Information Bulletin

Bulletin No: JC-16-05

Product Type: Mataway Overseeder

Subject: Optimal Seed dispersal.

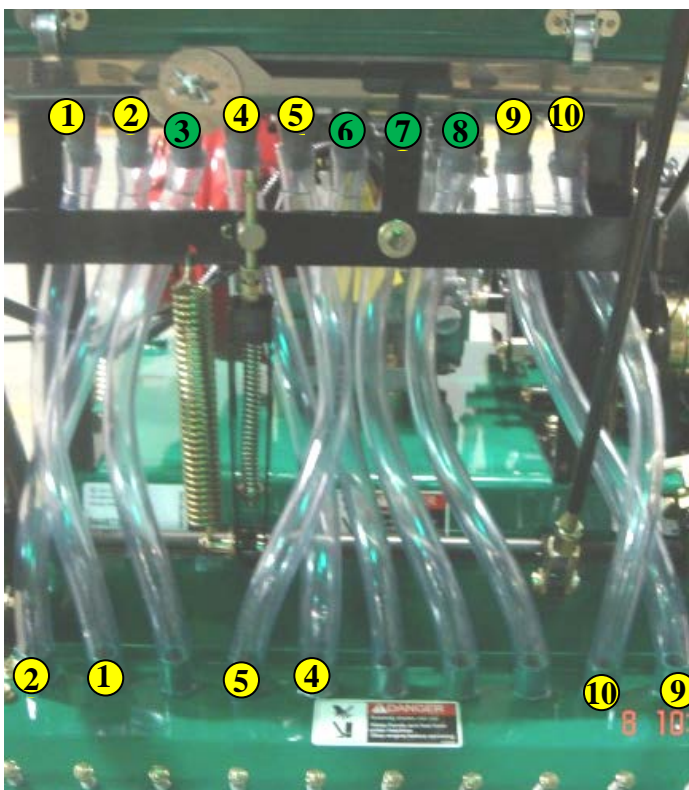
Information: Historically, we routed the seed dispersal tubes straight down. Based on end user customer feedback and the design of the hopper paddle wheel, we can get optimal seed dispersal if the tubes are intermingled. Please refer to the configuration shown below. We have also recently revised current production to this new routing.

Action Required: For optimum performance, pull tubes 1, 2, 4, 5, 9 & 10 off at the reel or the seed hopper assembly and route as shown.
